ISSUE	DATE	REVISION
A	16/11/22	DA Submission
B	06/03/23	RFI
C	27/09/23	LEC
D	08/11/23	LEC
E	21/11/23	LEC
F	29/01/24	Amended Issue for LEC

PROJECT
Terrace Houses

ADDRESS
2-6 Martin St, Roselands NSW 2196 Australia

Gross Floor Area

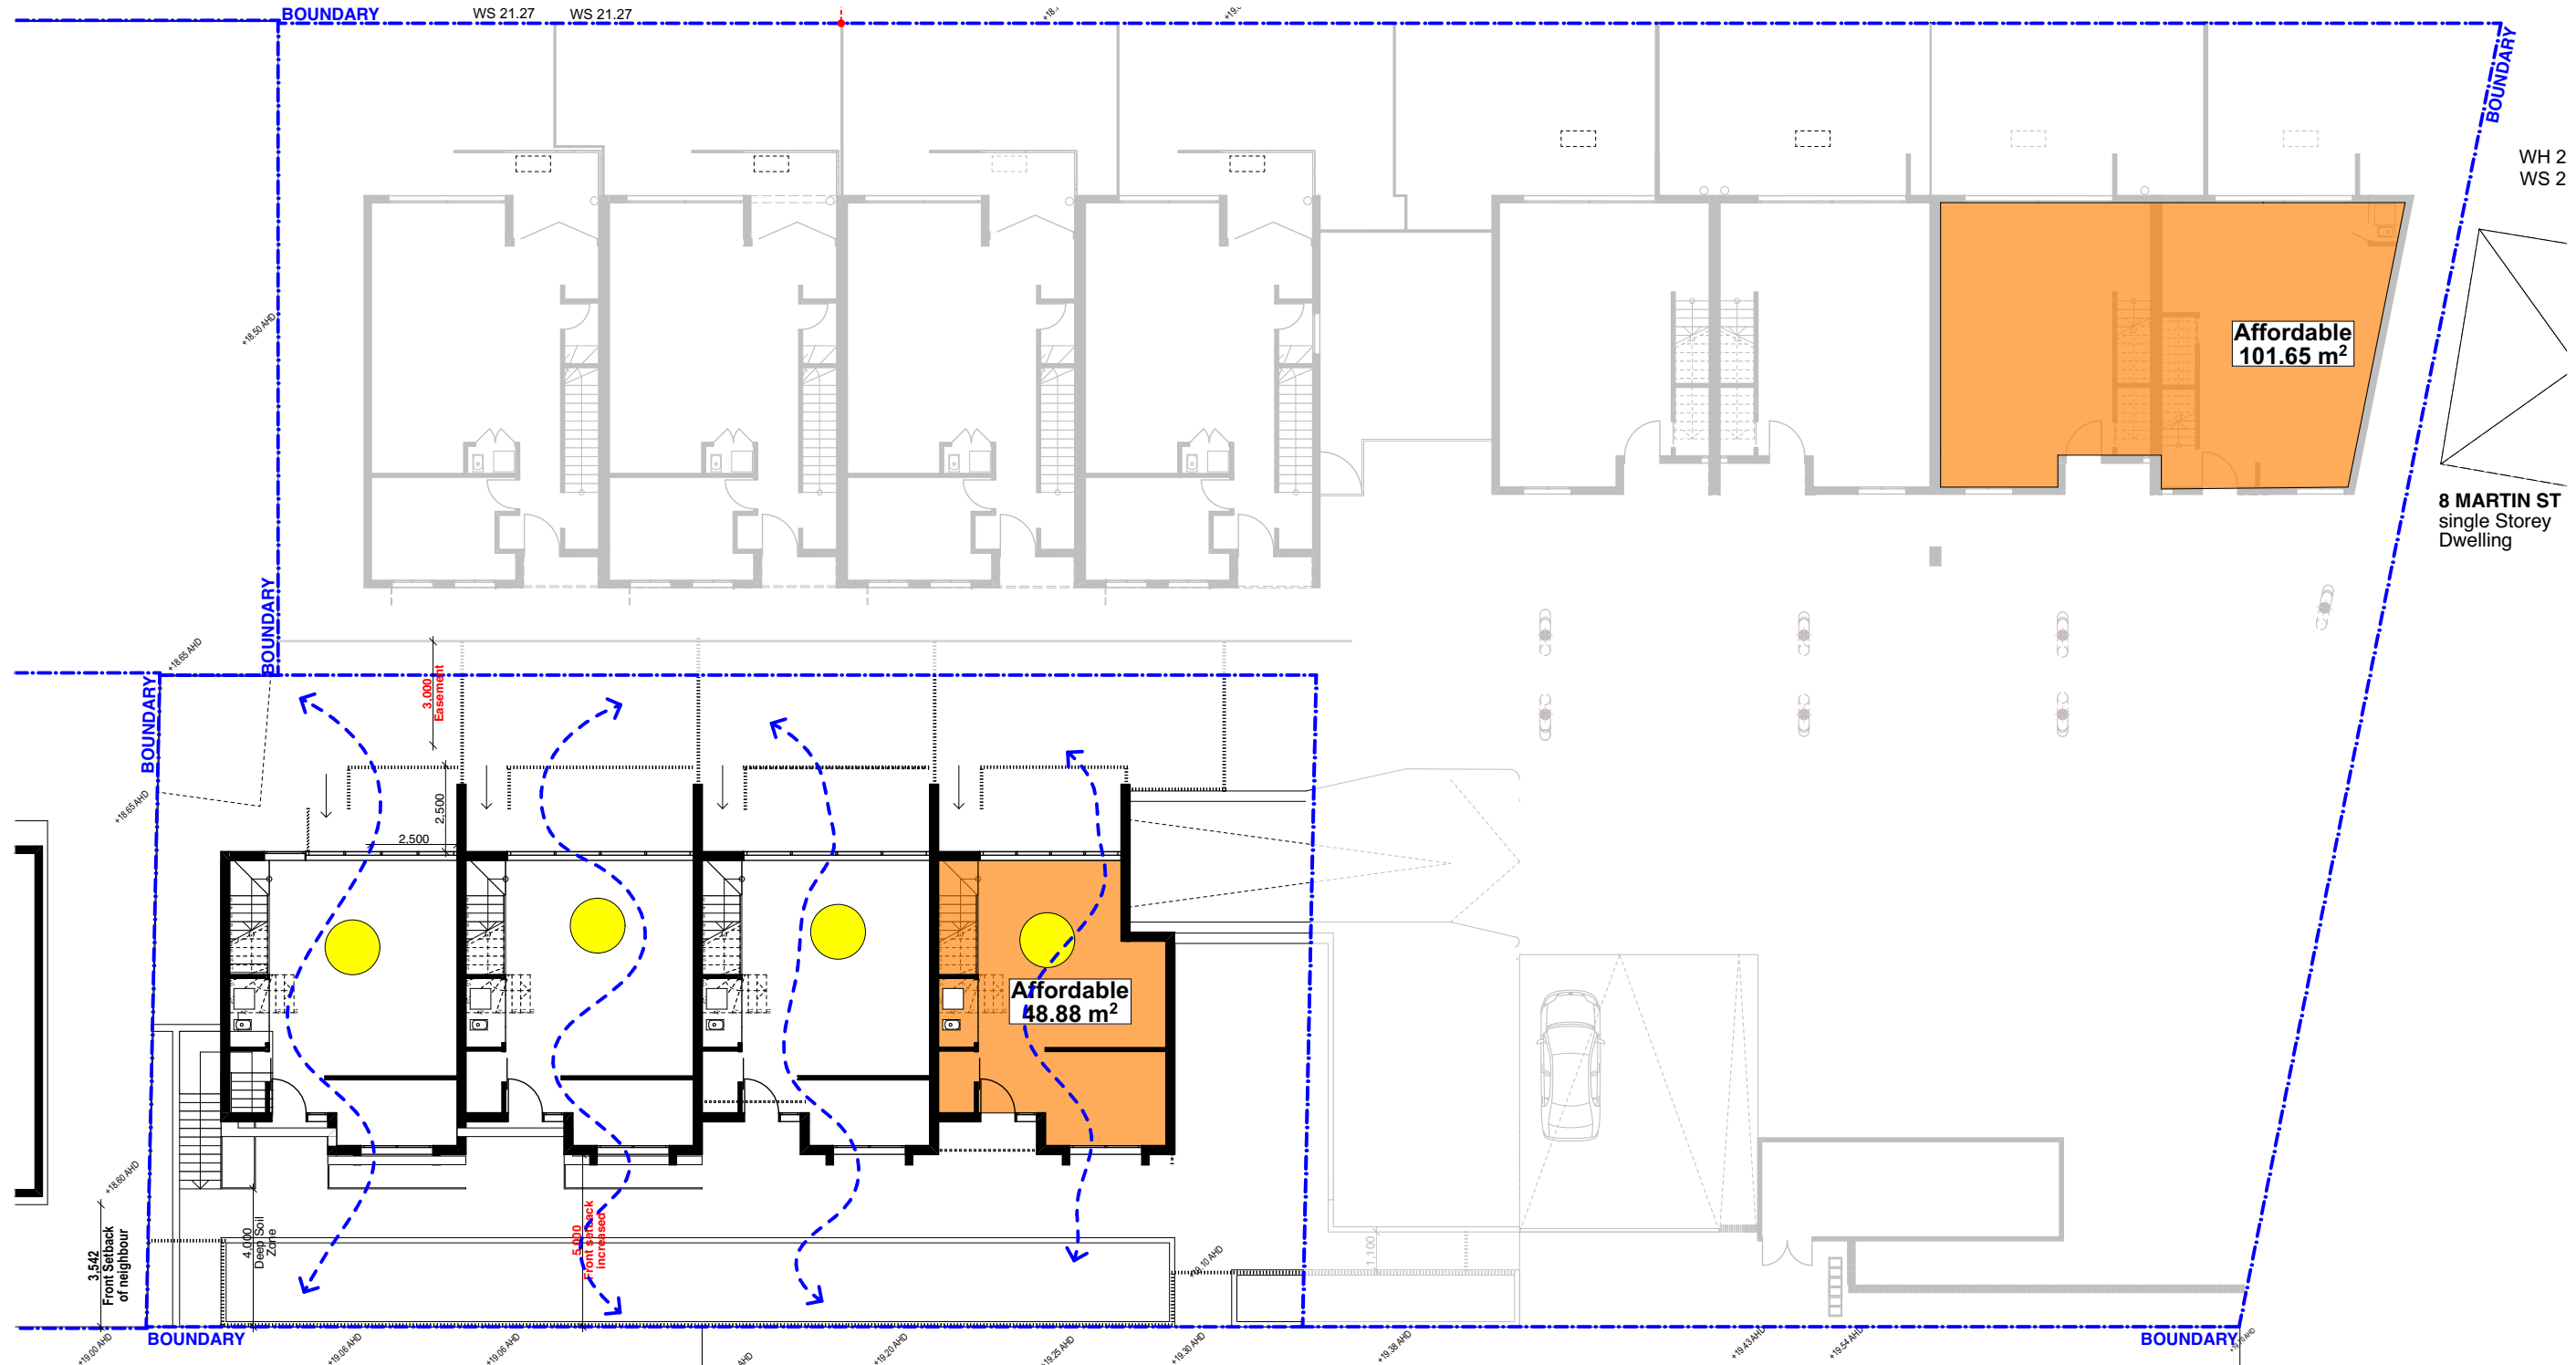
1. Calculations amended accordingly.

DRAWING Landscaped Area Calculation	REV F

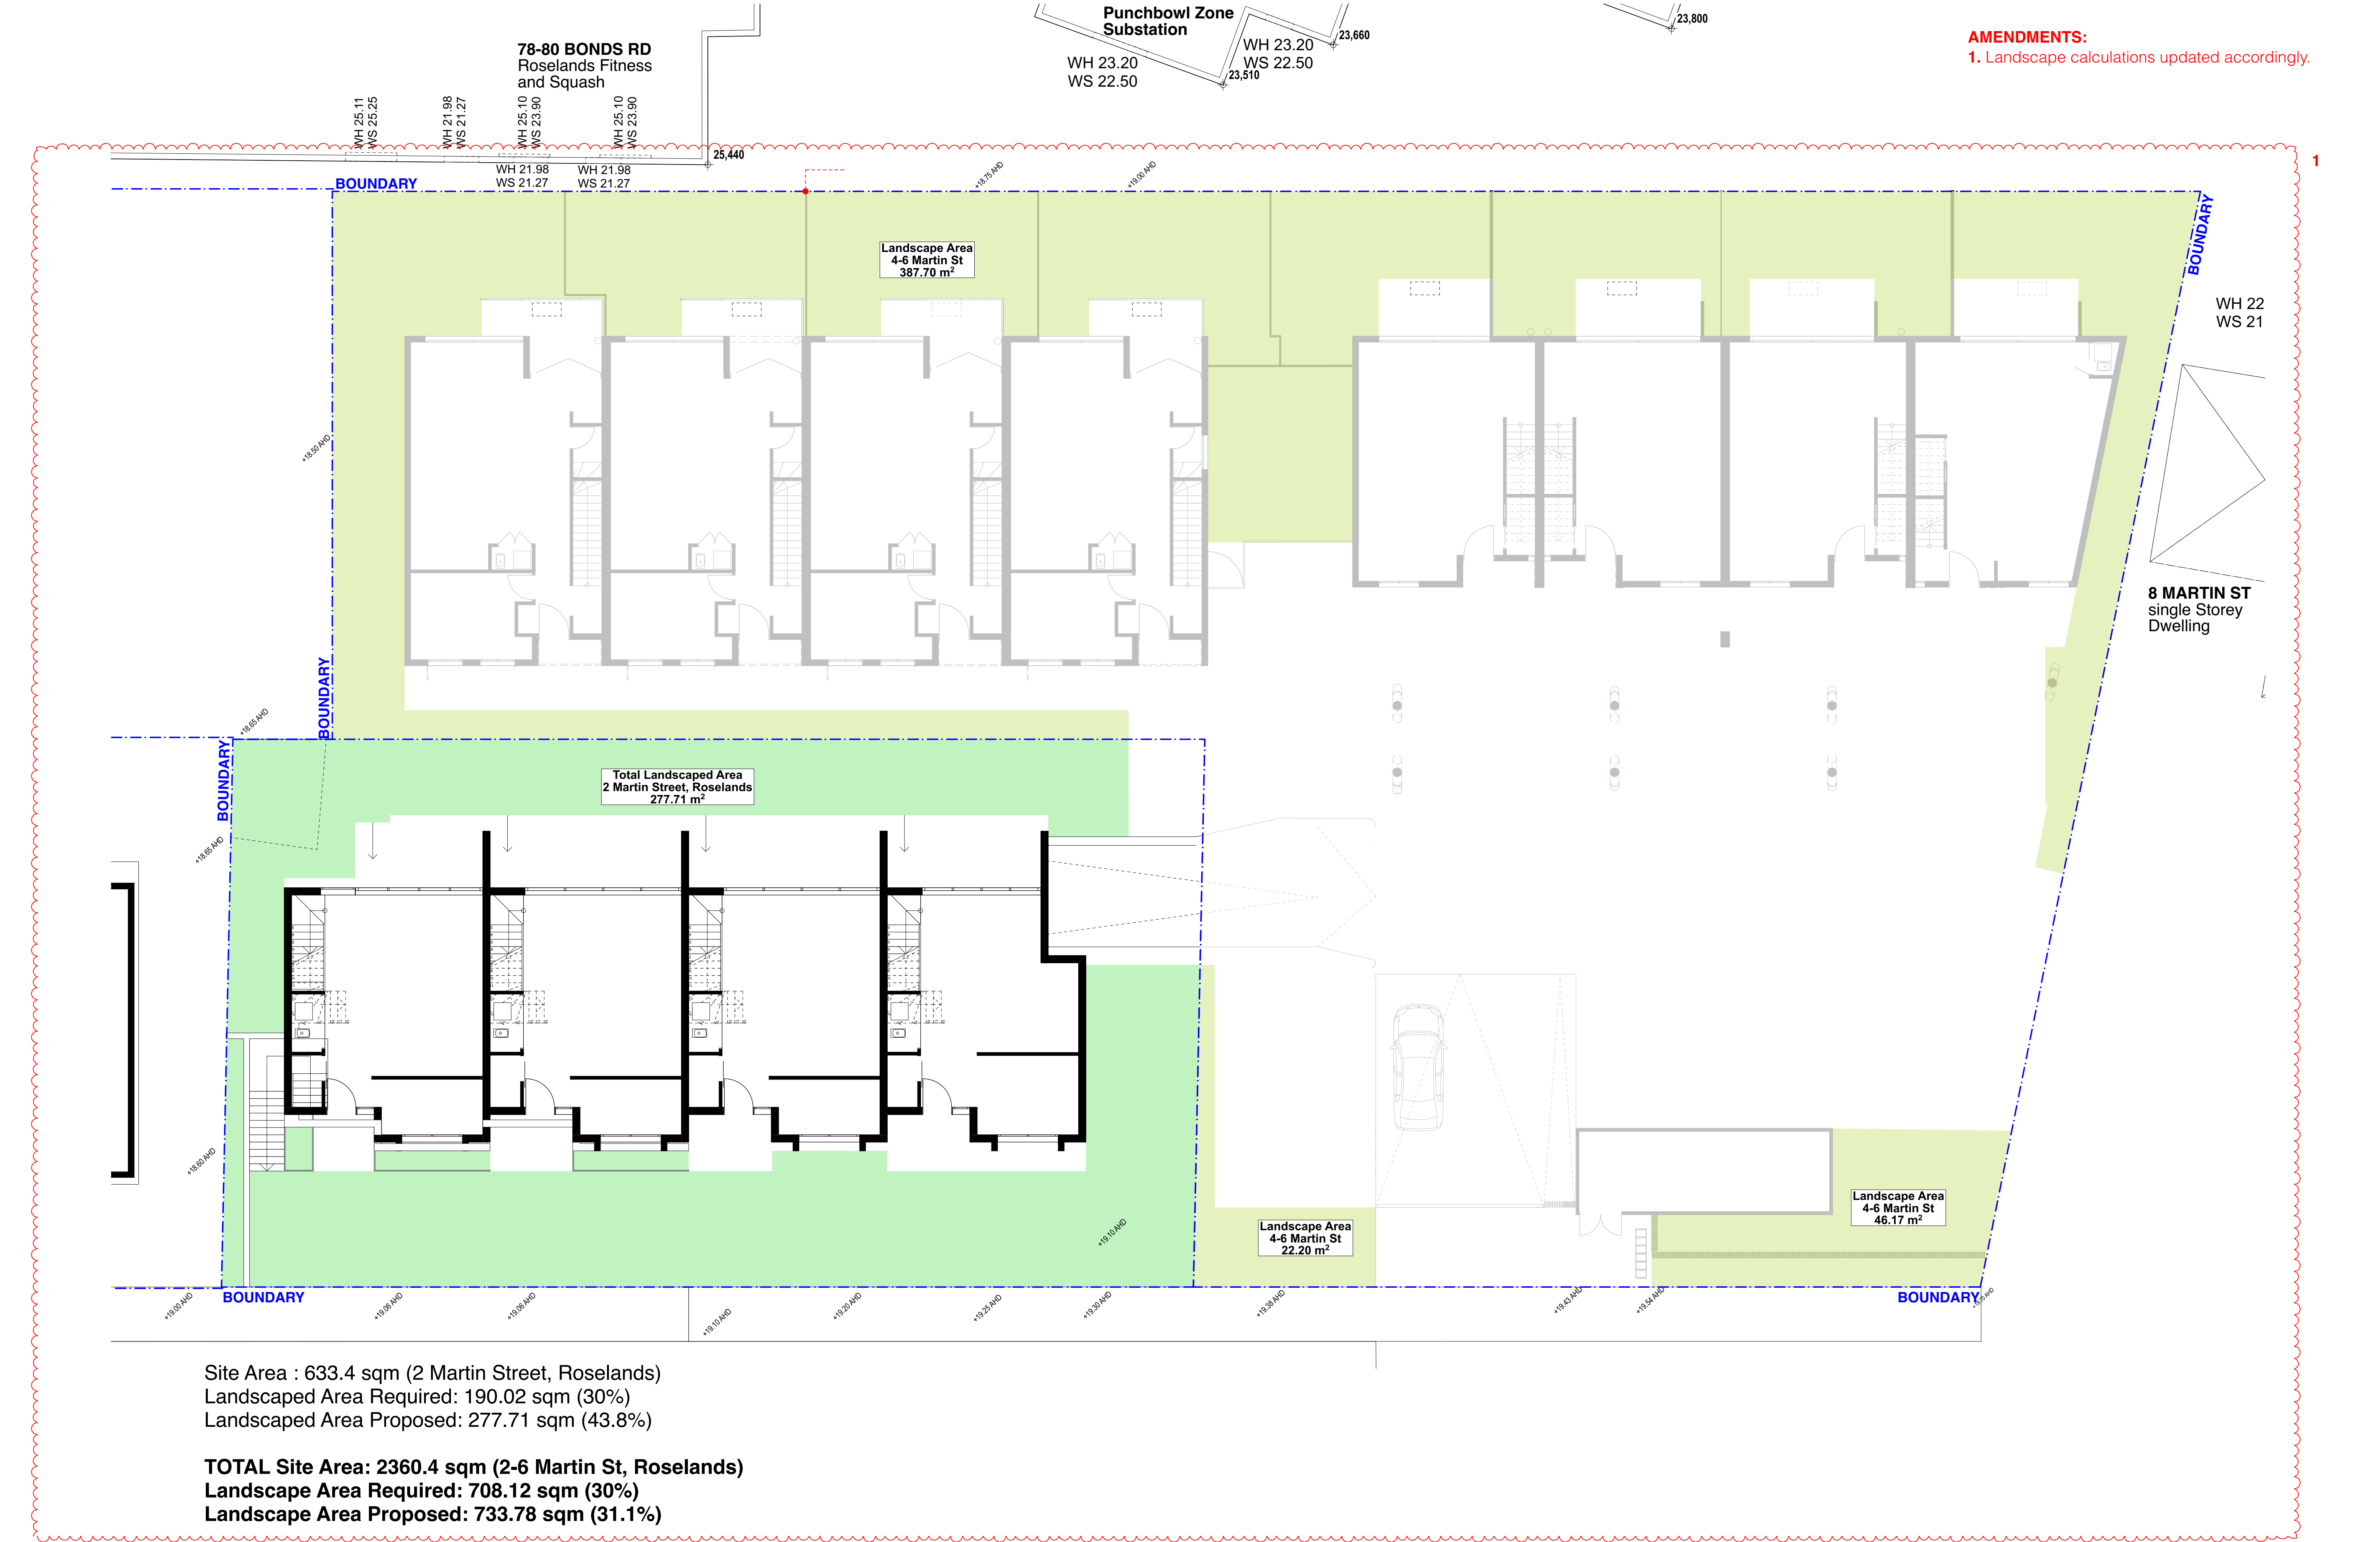
- AMENDMENTS TO 4-6 MARTIN ST
ORIGINAL APPROVED DA-84/2020:**
1. Entry driveway widened and pedestrian entry ramp relocated to eastern side of driveway.
 2. Bin room increased and shifted east to accommodate widened driveway. Landscape amended accordingly.
 3. Car spaces 10 and 11 relocated and visitor space included.
 4. Basement ramp to 2 Martin St included.
 5. Bicycles relocated.
 6. Pedestrian ramp to rear dwellings relocated.
 7. Easement relocated.

DRAWING
Deep Soil Area Calculation

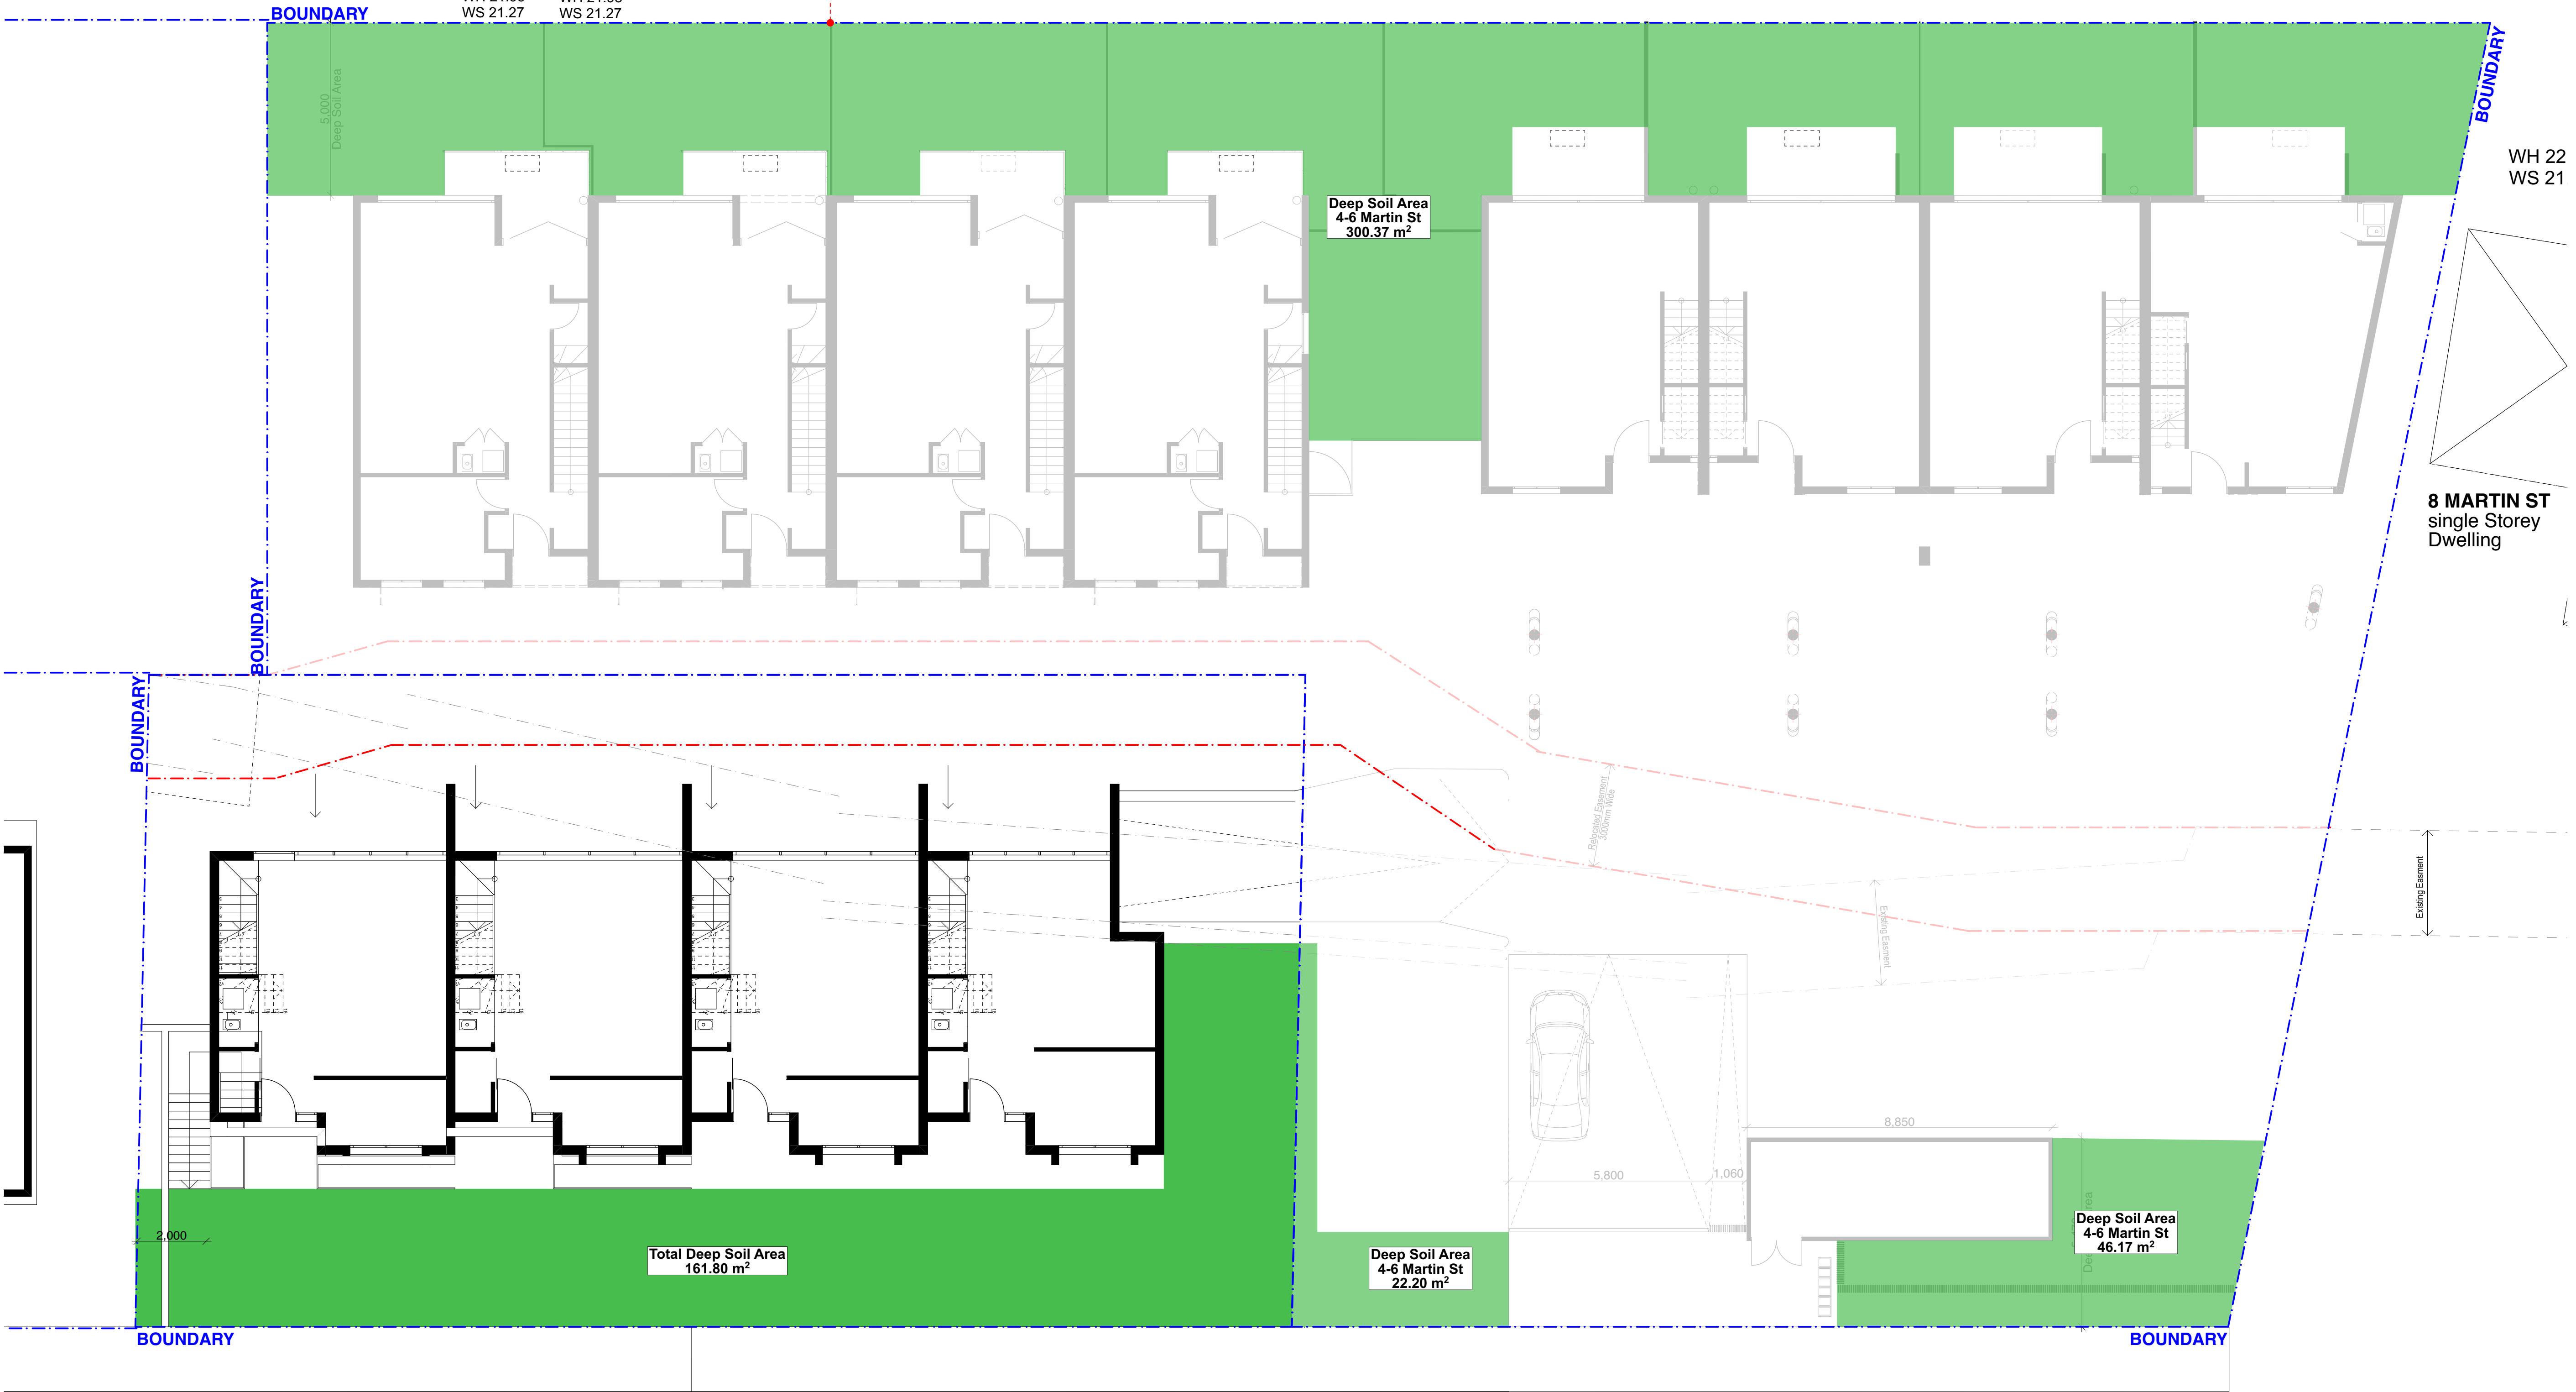
1. Deep Soil calculations updated accordingly.
